TERMINAL PART ASSY

001 TERMINAL COVER

TITLE		TERMINAL PART ASSY	
DWG. NO.		SC01D024	1/3

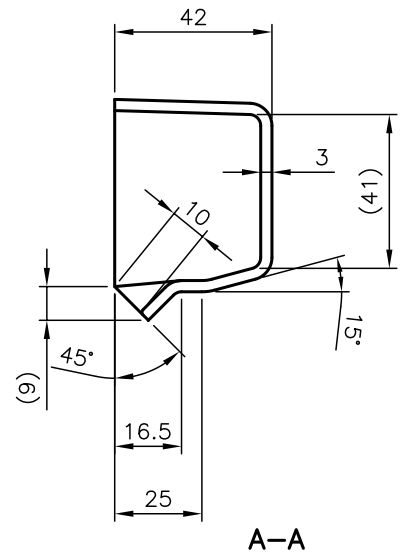
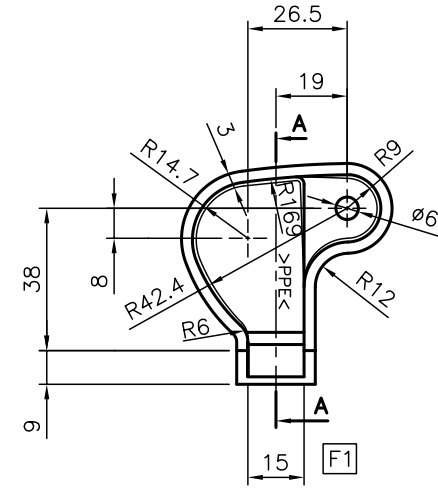
CHANGE
 F1 (B-5)
 DRAWING WAS AS BELOW.

E1 (A-5)
SPECIAL NOTE WAS
CHANGE.

E2 (C-6)
NOTES 1. MATERIAL
: POLYPHENYLENE
ETHER XYRON 500Z.
E3 FORM WAS
CHANGE.
10-09-21
J.SANTICHAJ
S.DUMRONGSAK
(NO. NCQ10I0161)

E1 SPECIAL NOTE
 THE PART SHOULD NOT CONTAIN PROHIBITED SUBSTANCES AND DETAIL SHOULD COMPLY WITH SCI-RoHS & REACH[SVHC] SUBSTANCE LIST. (STD100001)

NOTES 1. MATERIAL : POLYPHENYLENE ETHER
 D1 E2 XYRON 500Z or
 NORYL PX9406P
 2. THICKNESS : 3 mm.

003 FLANGE NUT

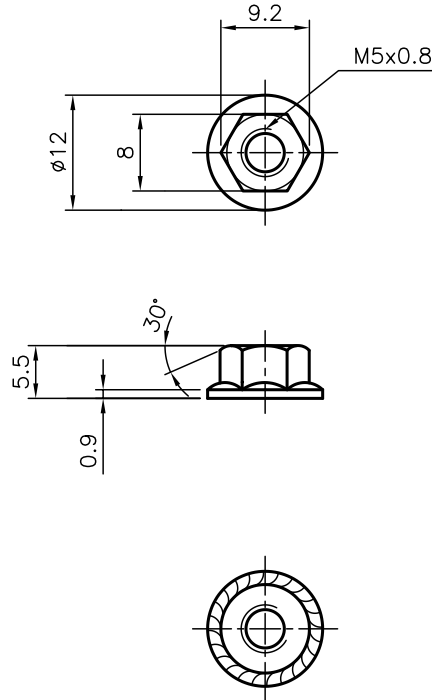
PART CODE WAS CHANGE
(CR12D116H01) TO
(SC12D378H01).
06-01-19
W.SUNPET
S.DUMRONGSAK
